ON Semiconductor

Product Bulletin

Document # : PB20643XA
Issue Date: 21 May 2015

Title of Change:	Change of Carrier Tape Design.
Effective Date:	Effective Immediately
Contact information:	<Rowena.Naigar@onsemi.com><Hiroshi2.Kobayashi@onsemi.com> <Dennis.Balignasay@onsemi.com>
Type of notification:	ON Semiconductor considers this change approved unless specific conditions of acceptance are provided in writing. To do so, contact <PCN.Support@onsemi.com>.

Current Design

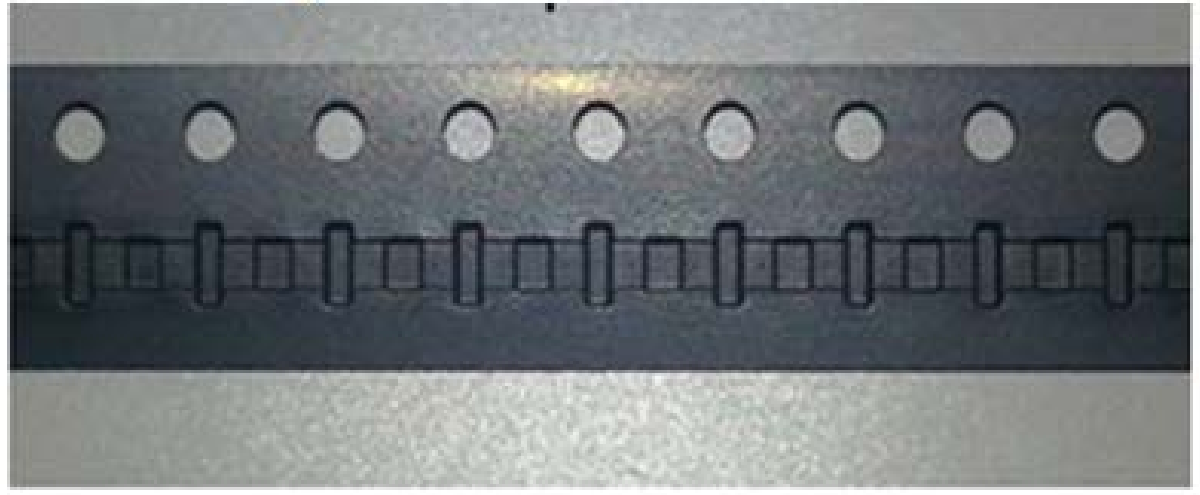
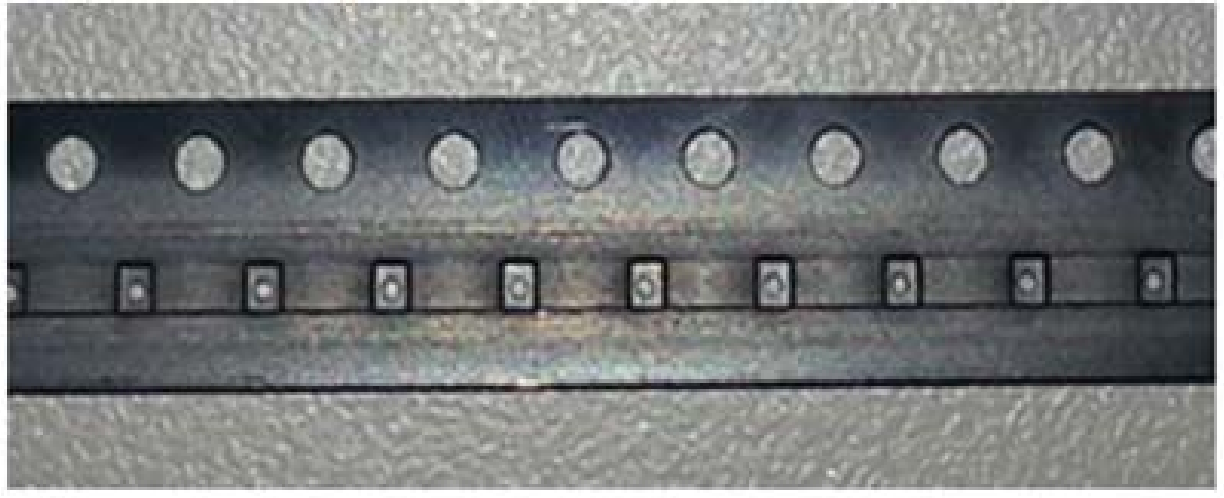
- Change design of CARR(WLP0.9X1.1X650) from without pocket hole to with pocket hole
- Standardize carrier tape design by removing rectangular pocket between device pocket

- Without pocket hole
- With rectangular pocket in between device pocket

- With 0.35 mm pocket hole
- Rectangular pocket is removed
